**LONGVIEW VALUE ENGINEERING STUDY
WATER SUPPLY ALTERNATIVES**

VE IDEA NUMBER: N1

DESCRIPTION: Use conventional filtration at Mint Farm

FIGURE 3

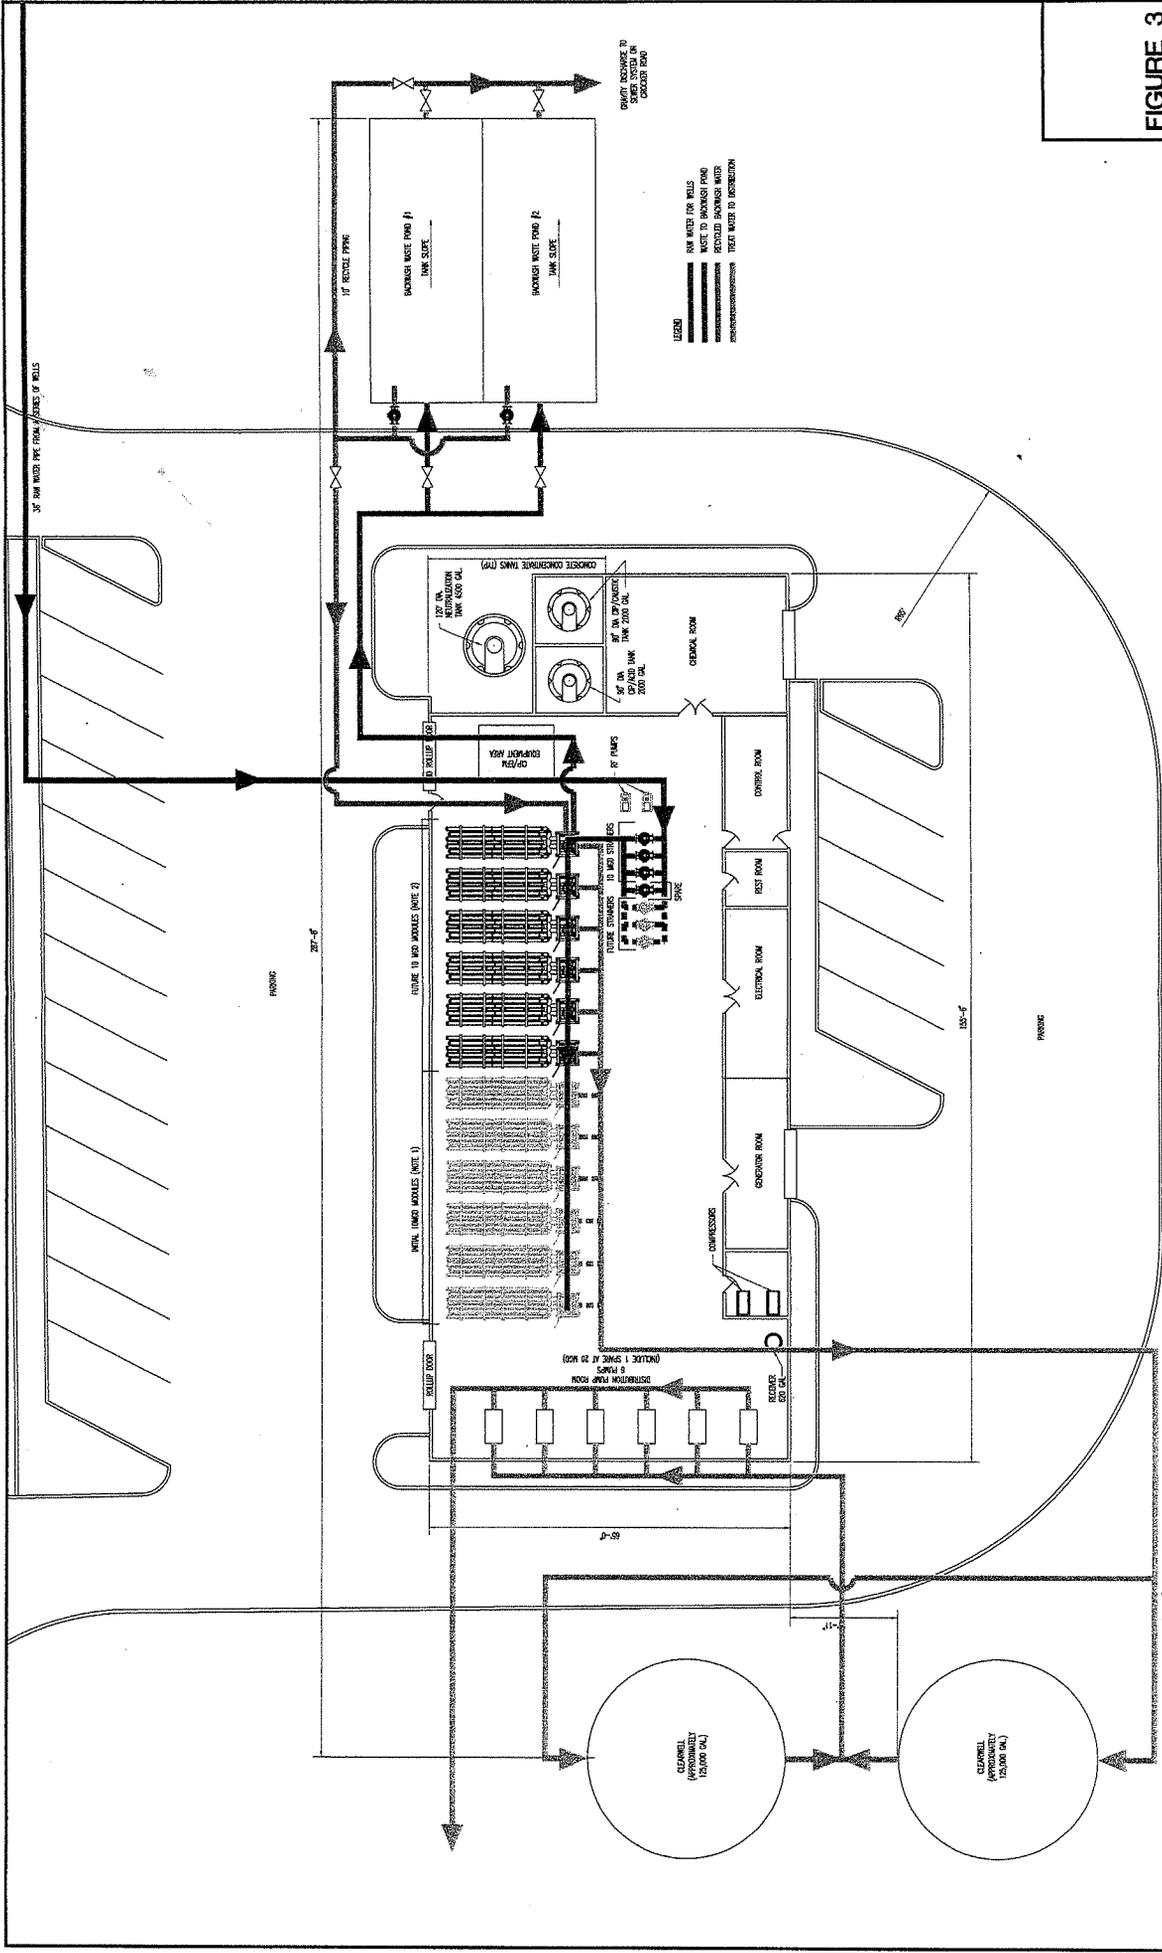
New 20 mgd microfiltration plant to treat groundwater produced from new wells at the Mint Farm. Chemicals for iron and manganese removal and membrane replacement were not included in the O&M cost.

20 mgd Microfiltration system - see
Fig. 3, site Layout by PACE (attached)

New 20 mgd mixed media gravity filtration plant to treat groundwater from new wells at the Mint Farm. Includes chemical conditioning for iron, manganese and arsenic removal. See attached sketch of layout of plant and attached detailed cost estimate.

RELATIVE PLANT FOOTPRINTS

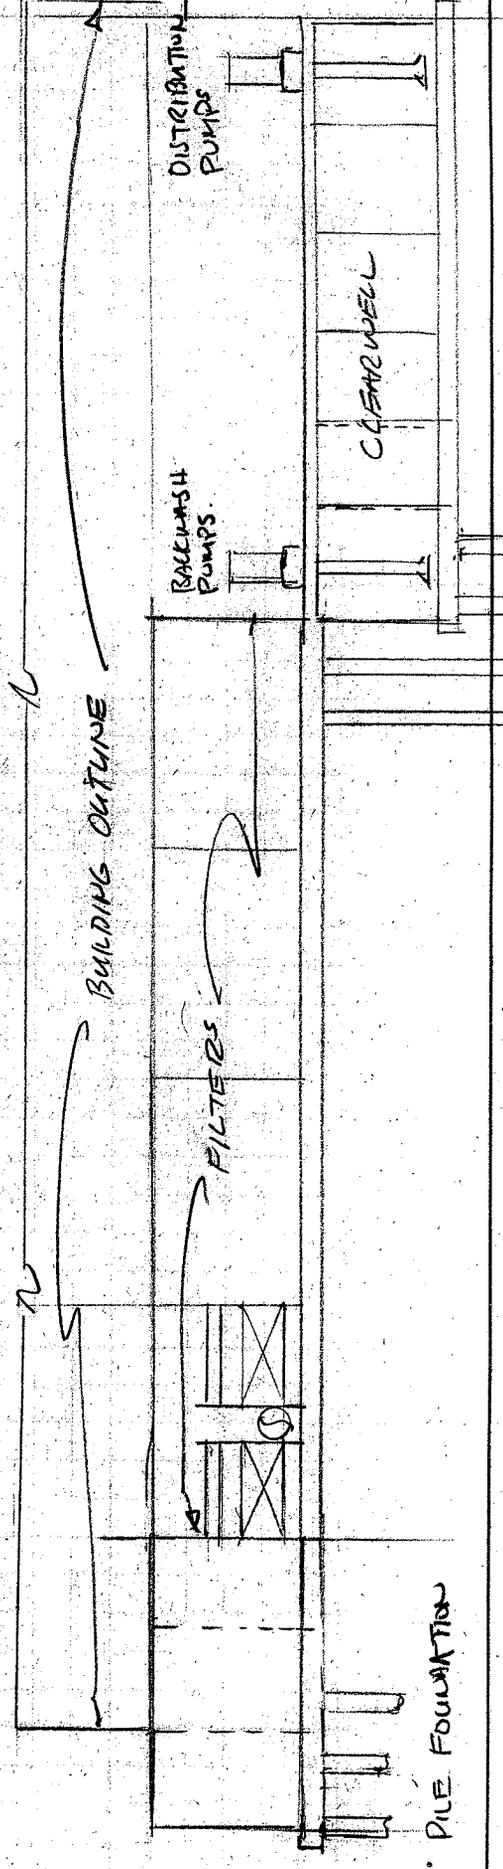
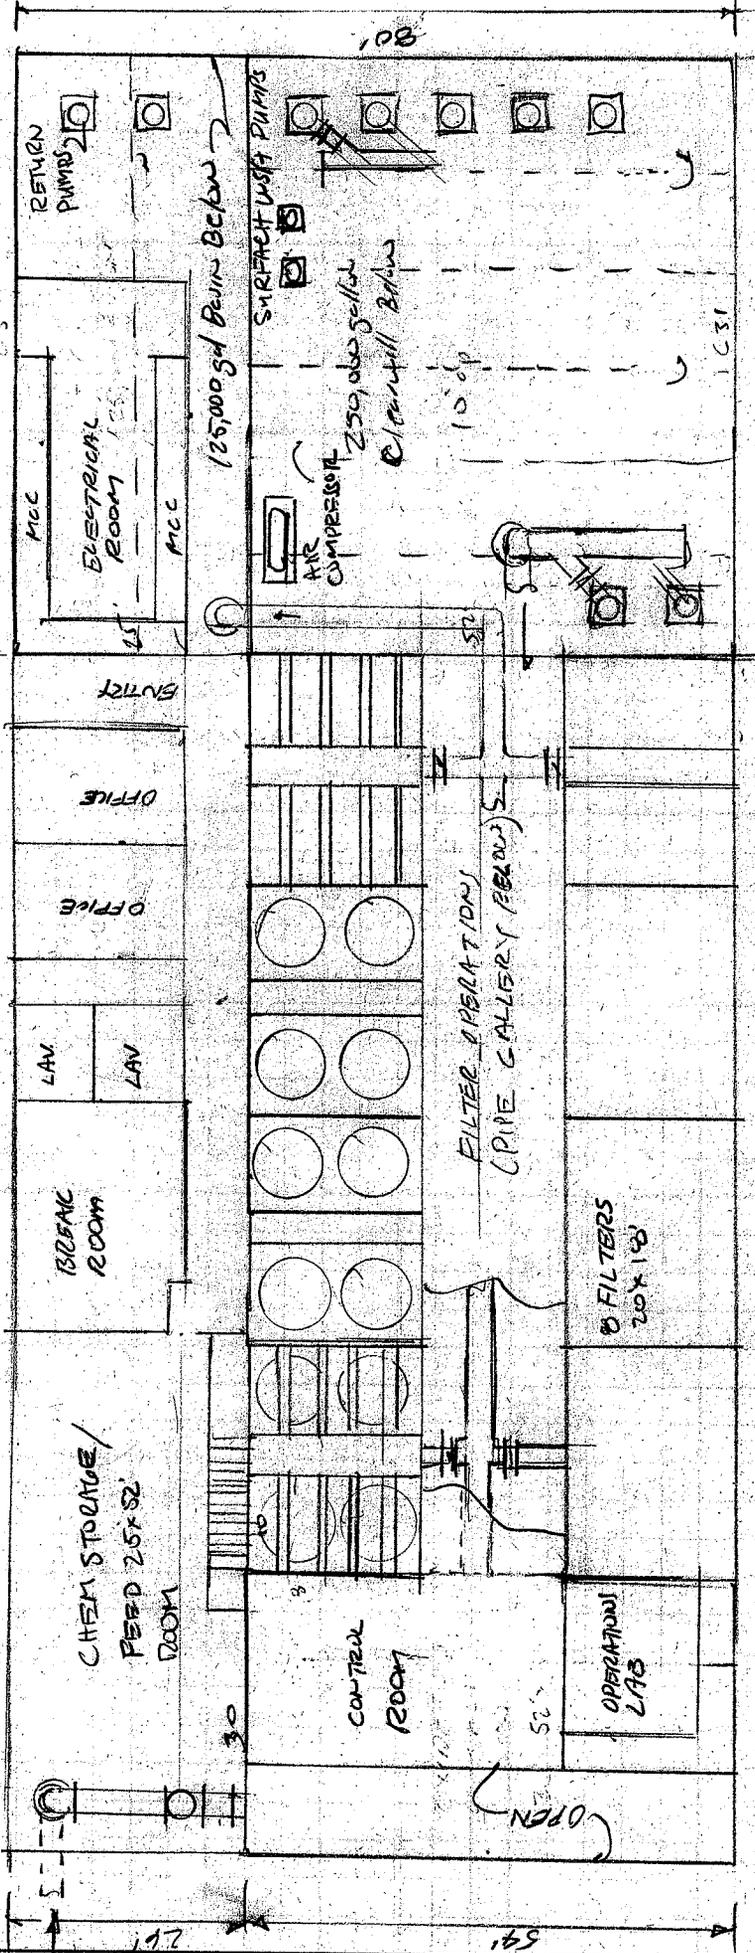
CONVENTIONAL PLANT
VE layout - see N1

MEMBRANE PLANT
(per SITE LAYOUT, Figure 3 by PAGE)

VE STUDY
ITEM N14

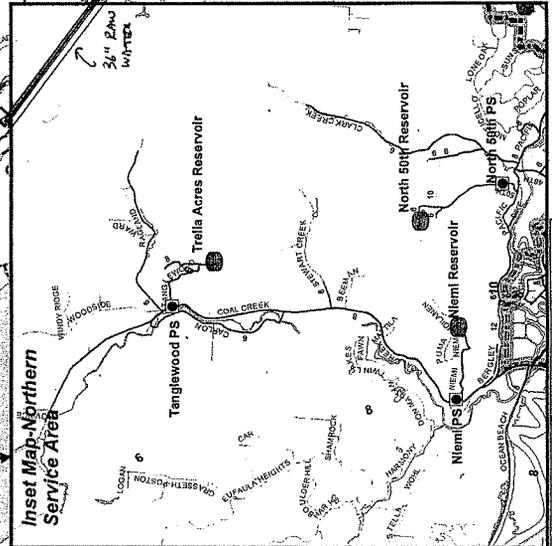
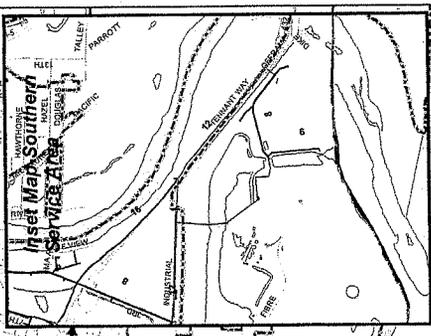
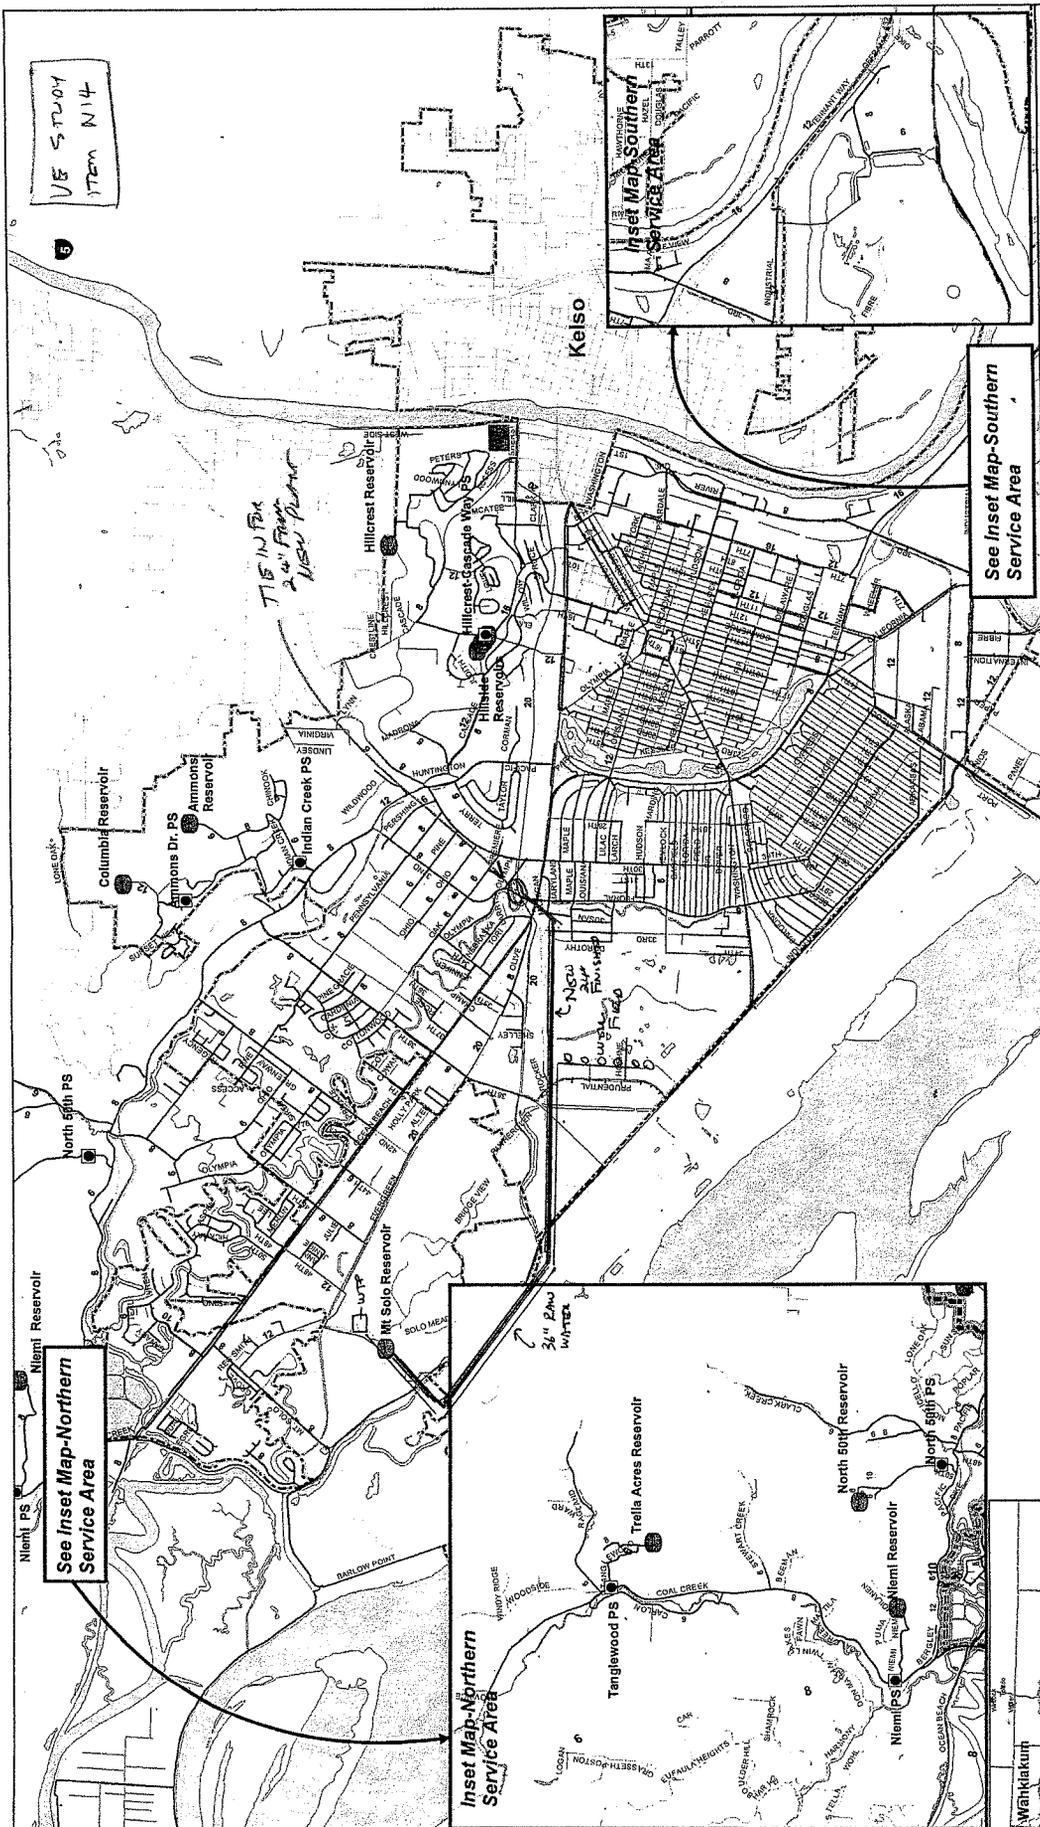
Construct plant on piling at Mint Farm site where foundation conditions are poor

Relocate treatment plant to Mt. Solo reservoir site where piling would not be needed
36" raw water and 24" finished water lines on south side of Mt. Solo

(VE team suggests evaluation of relocating well field to area just south of Mt. Solo to avoid industrial park concern and to reduce piping costs. If feasible, the cost shown on this worksheet for relocating the plant to Mt. Solo would be reduced substantially)
